**CHANGE NOTICE**

1. The Boeing Company Post Office Box 58747 Houston, TX 77258		2. <input type="checkbox"/> Proposed <input checked="" type="checkbox"/> Approved		3. Code Ident. 2B945		4. Doc. No. SSP 30240C

11. Document Title: Space Station Cable/Wire Design and Control Requirements for Electromagnetic Compatibility				12. Effectivity All Units			
THIS NOTICE INFORMS RECIPIENTS THAT THE DOCUMENT IDENTIFIED BY THE NUMBER (AND REVISION LETTER) SHOWN IN BLOCK 4 HAS BEEN CHANGED. THE PAGES CHANGED BY THIS CDCN BEING THOSE FURNISHED HEREWITH AND CARRYING THE SAME DATE AS THIS CDCN. THE PAGES OF THE PAGE NUMBERS AND DATES LISTED BELOW IN THE SUMMARY OF CHANGED PAGES COMBINED WITH NON-LISTED PAGES OF THE ORIGINAL ISSUE OF THE REVISION SHOWN IN BLOCK 4 CONSTITUTE THE CURRENT VERSION OF THIS DOCUMENT.

13. CDCN No.	14. Pages Changed (Indicate Deletions)				S*	A*	15. Date
002	Revision and History page. Pages 3-2 and 3-3 Page C-1.				X X X		07/09/99
002	Page C-2.					X	
	Order of Incorporation: DCN 002

**FIGURE C.3.2.1.1-1 CID FAULT PREVENTION**

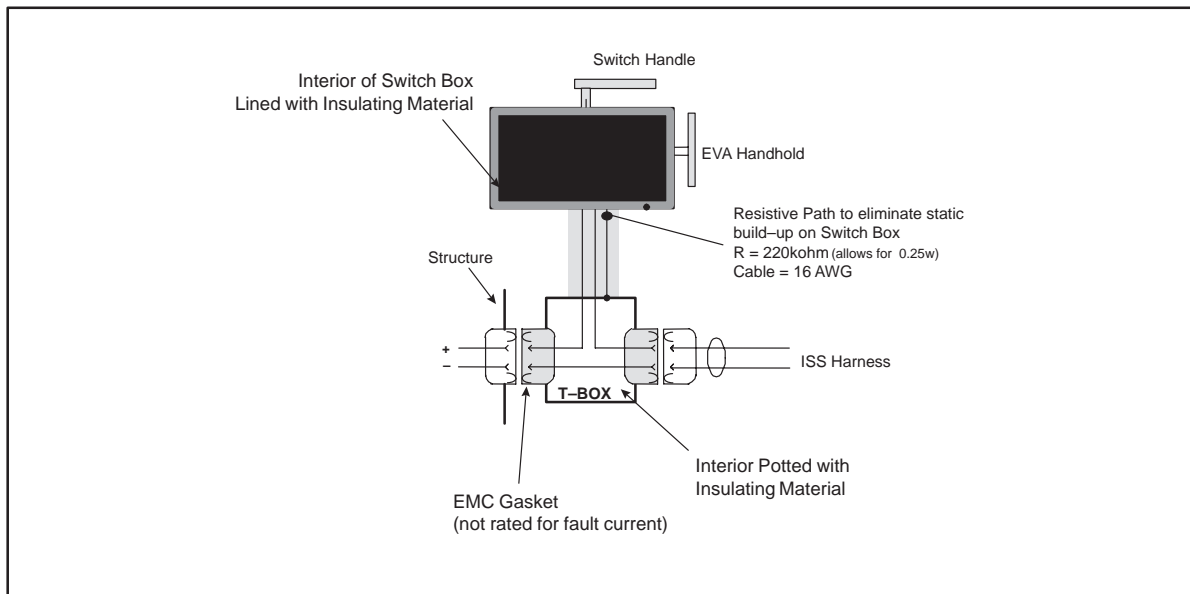
Exception: The Circuit Interrupt Device (CID) (PNs LAB DDCU1A P301/J201, LAB DDCU1B P302/J202, LAB DDCU2B P316/J216, LAB DDCU3B P315/J215, Z1 CHANNEL2B P240/J440, Z1 CHANNEL4B P230/J430, S0 CHANNEL2B P488/J487, S0 CHANNEL4B P485/J484) is not required to meet the Class H bonding requirement of SSP 30245, paragraphs 3.2.1.1, 3.2.1.1.1, and 3.2.1.1.2. DCN 002

Rationale: The Circuit Interrupt Device (CID) is susceptible to hot to chassis faults which may cause fault currents that could create an electrical hazard. To protect against such an occurrence, the following precautions as shown in Figure C.3.2.1.1-1 will be taken: DCN 002

1. A resistive bond wire is added between the switch box and the "T" box to prevent the fault current from traveling to the connector. DCN 002
2. The switch box will be coated inside with a Halar coating to prevent the hot line from touching the switch box in the event of a failure. DCN 002
3. Insulating material will be placed inside the "T" box to prevent the wires from moving in the event of a failure. DCN 002

With these precautions, it is believed that the CID will be sufficiently isolated from the chassis, and the risk of causing an electrical hazard will be sufficiently reduced. DCN 002
